BID # WMC24-02

ADDENDUM NUMBER 06

Berlin MEP Upgrades

September 20, 2024

MECHANICAL RTU PLAN
SCALE: NTS

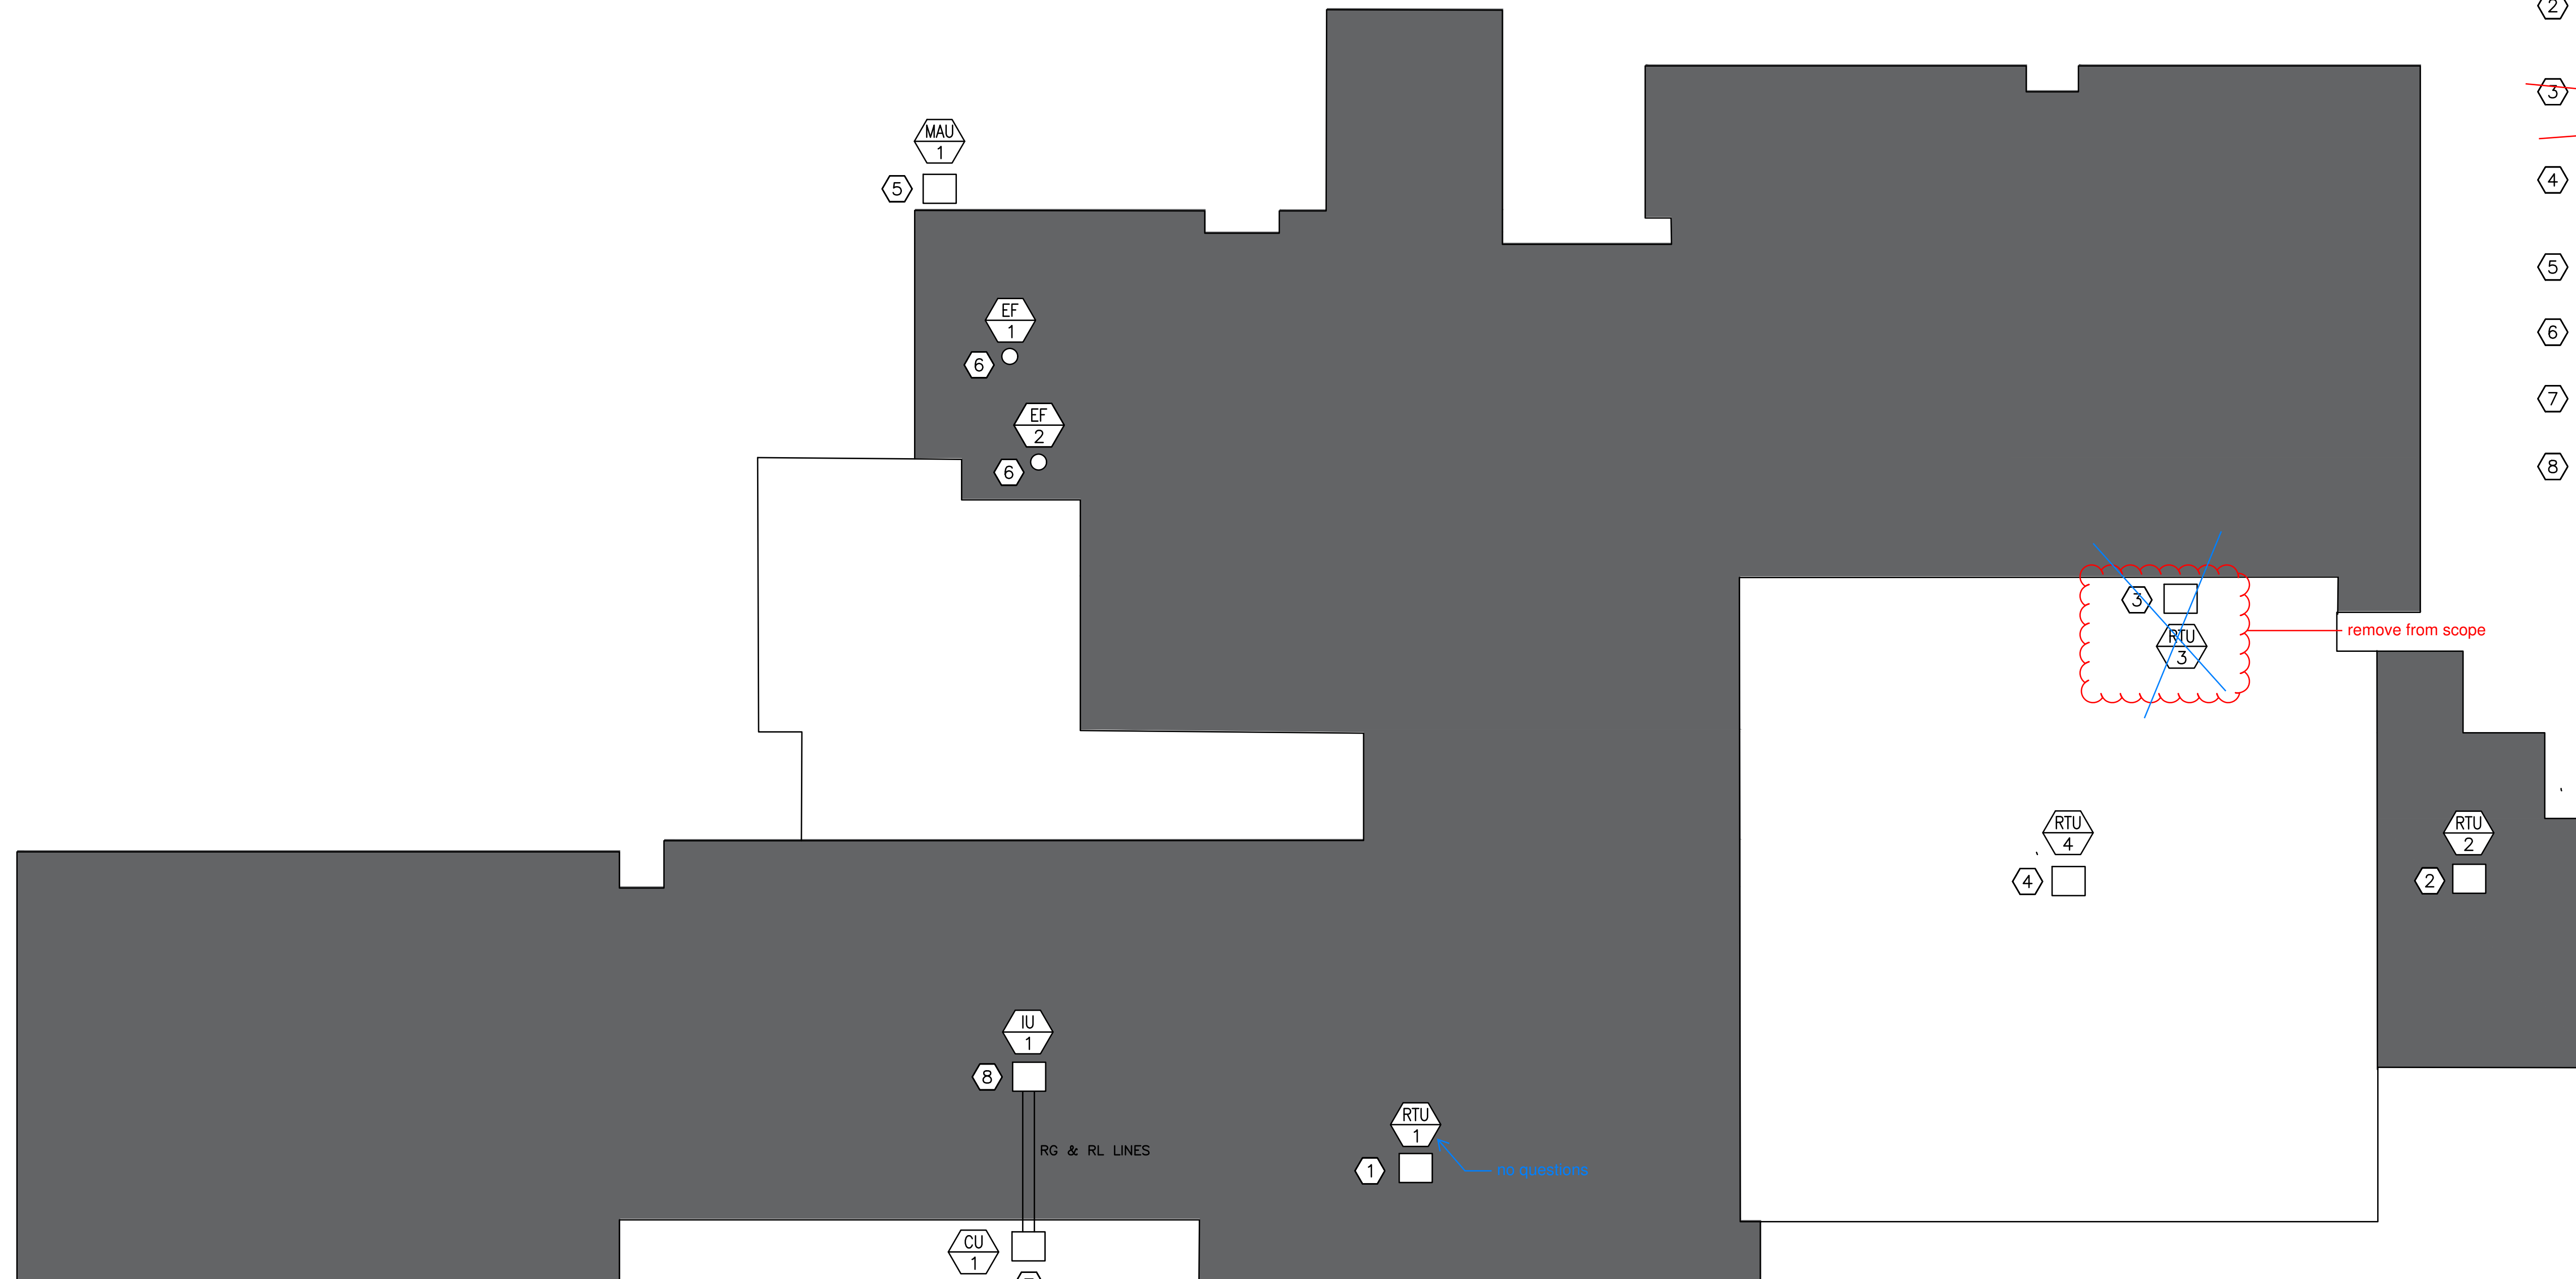
ADDENDUM SEE JOHNSON CONTROLS ROOF TOP UNIT SELECTIONS FOR RTU 1,2 & 4, RTU 3 IS REMOVE FROM THE PROJECT, CONTROLS OF RTU 3 ARE INCLUDED AS SHOWN ON M-702

- ~~JOHNSON CONTROLS SINGLE PACKAGE R-410A AIR CONDITIONER W/ HEAT FOR TRANE LP GAS FIRED RTU REPLACEMENT SERVING THE LIBRARY OFFICE. MODEL NUMBER: ZQG04D2C1AA1C321A3.~~

35 CONTROL VALVES - SEQUENCE OF OPERATIONS

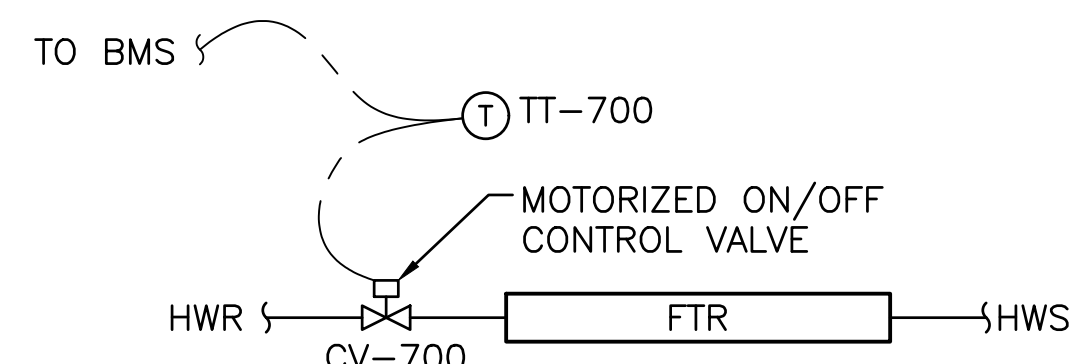
The Hot Water Control Valves are deleted for the RFP.

DOMESTIC WATER SUPPLY ENTRANCE

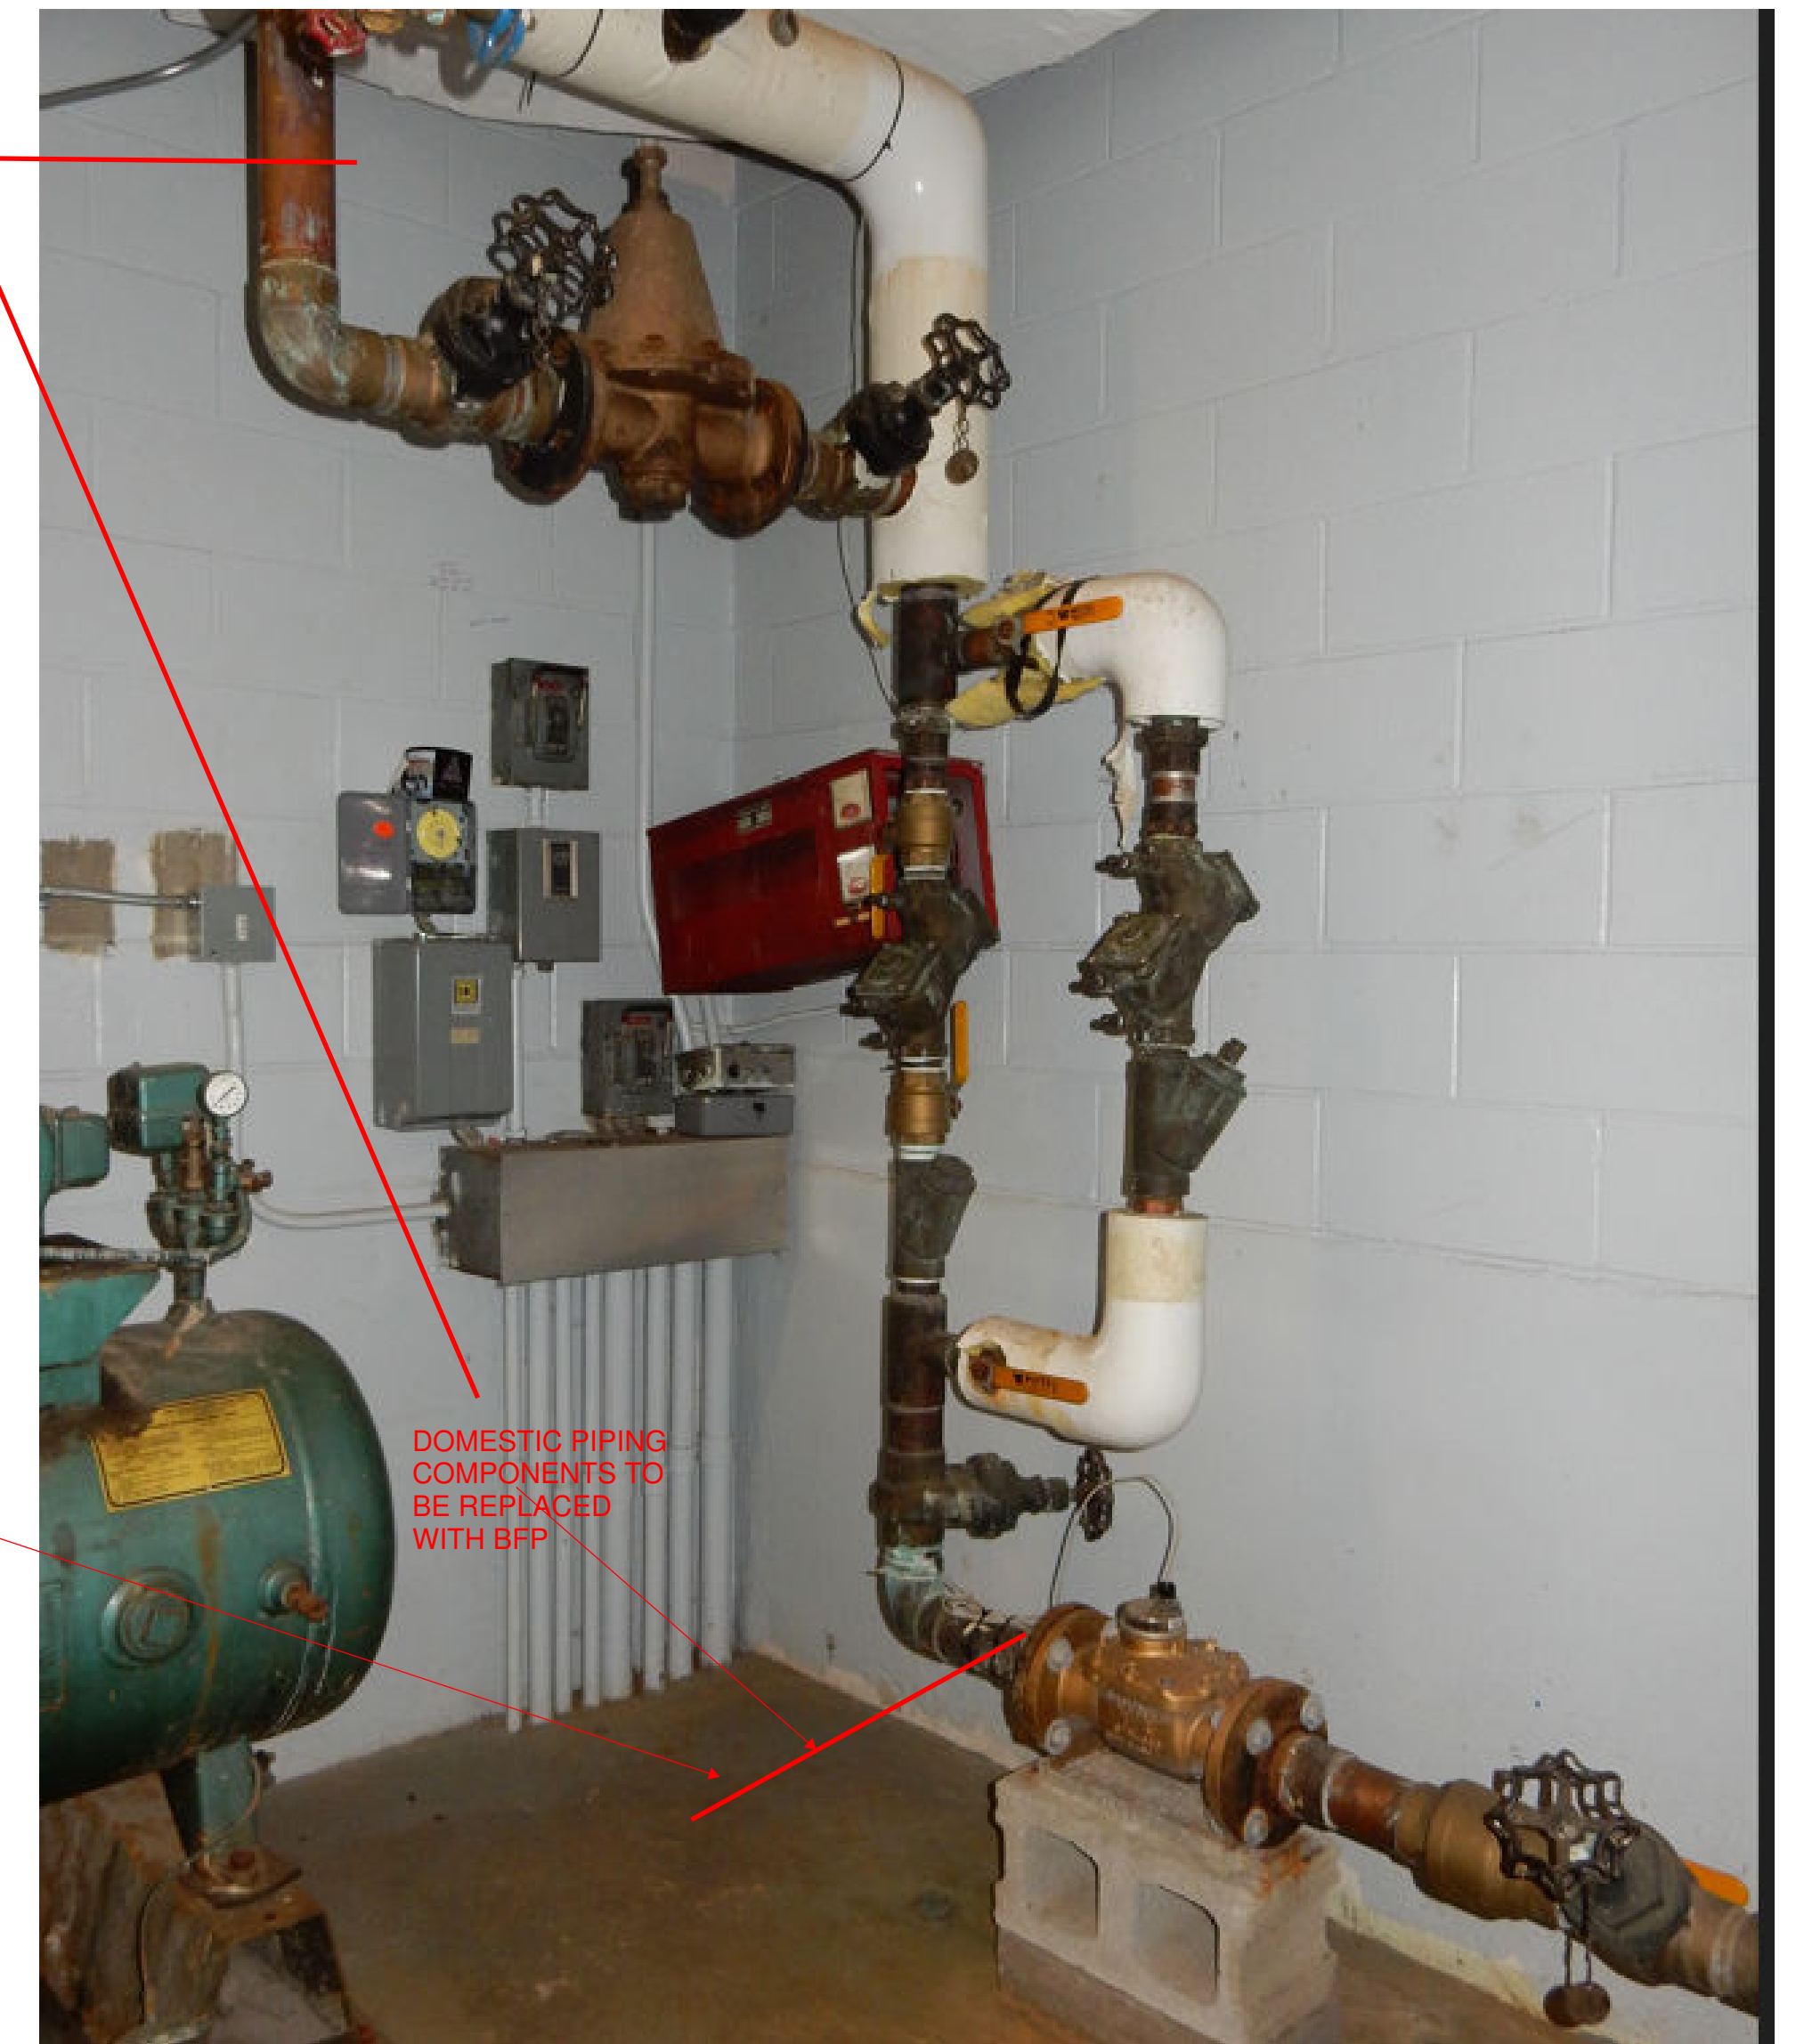
MOVED SCOPE
BREAK HERE PER
PHOTO TO THE
RIGHT

DOMESTIC PIPING
COMPONENTS TO
BE REPLACED
WITH BFP
